Project	IEEE 802.16 Broadband Wireless Access Working Group < http://ieee802.org/16 >	
Title	A method of scanning neighbor BSs periodically	
Date Submitted	2004-06-07	
Source(s)	Kihyoung Cho, Yongho Kim LG Electronics, Inc. 533, Hogue-1dong, Dongan-gu, Anyang-shi, Kyongki-do, Korea	Voice: 82-31-450-2945 Fax: 82-31-450-7912 [mailto: kihyoung@lge.com, ronnykim@lge.com]
Re:	This is a response to a Call for Comments IEEE802.16e Handover Adhoc.	
Abstract	In this contribution, a method of supporting periodic scanning is provided.	
Purpose	This document is submitted for review by 802.16e Working Group members	
Notice	This document has been prepared to assist IEEE 802.16. It is offered as a basis for discussion and is not binding on the contributing individual(s) or organization(s). The material in this document is subject to change in form and content after further study. The contributor(s) reserve(s) the right to add, amend or withdraw material contained herein.

A method of scanning neighbor BSs periodically

2. Proposed Changes

Figure E.1—Example BS advertisement and scanning (without association) by MSS request

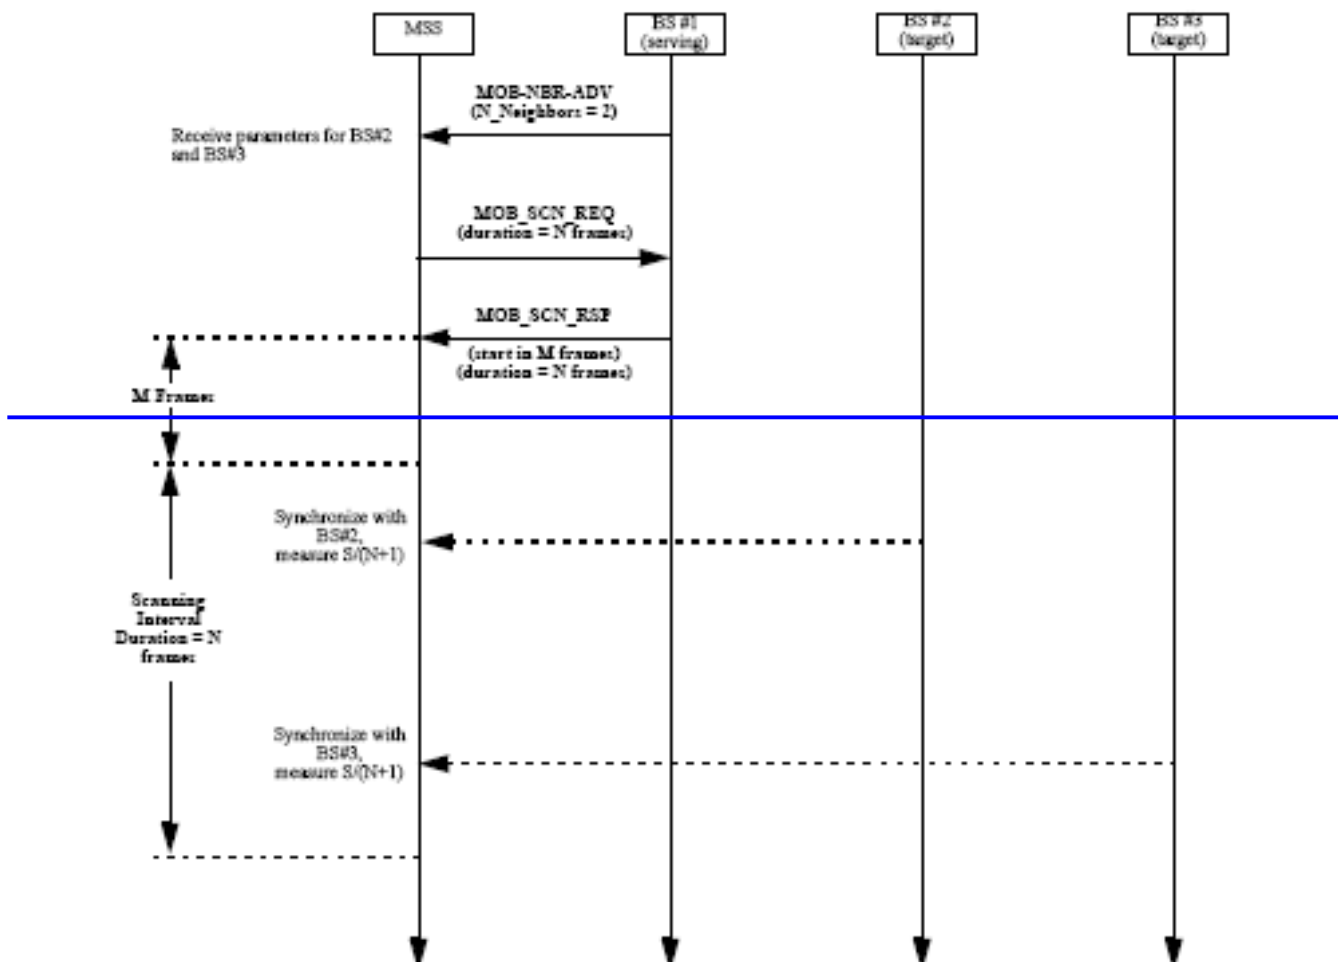
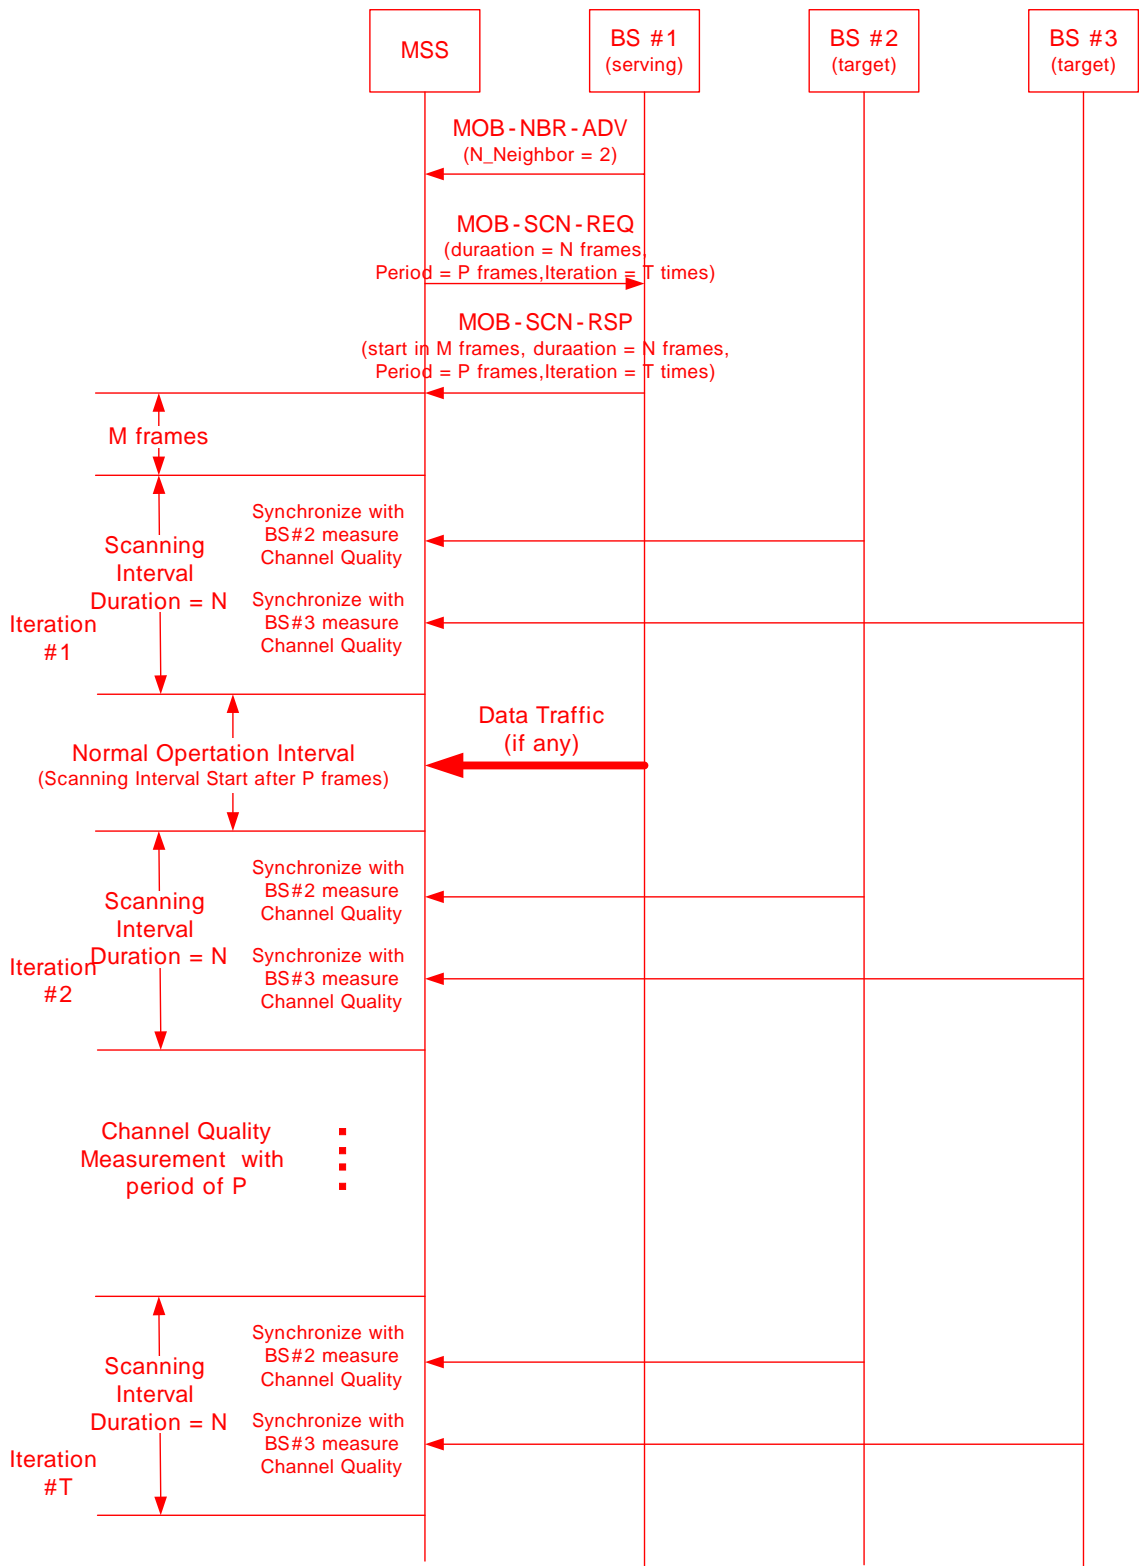
[Modify the Figure E.1– Example BS advertisement and scanning (without association) by MSS request]

The following figures describes the messages flow for neighbors advertisement and scanning of neighbors by the MSS request, BS request and periodic scanning of neighbors during hand-over.
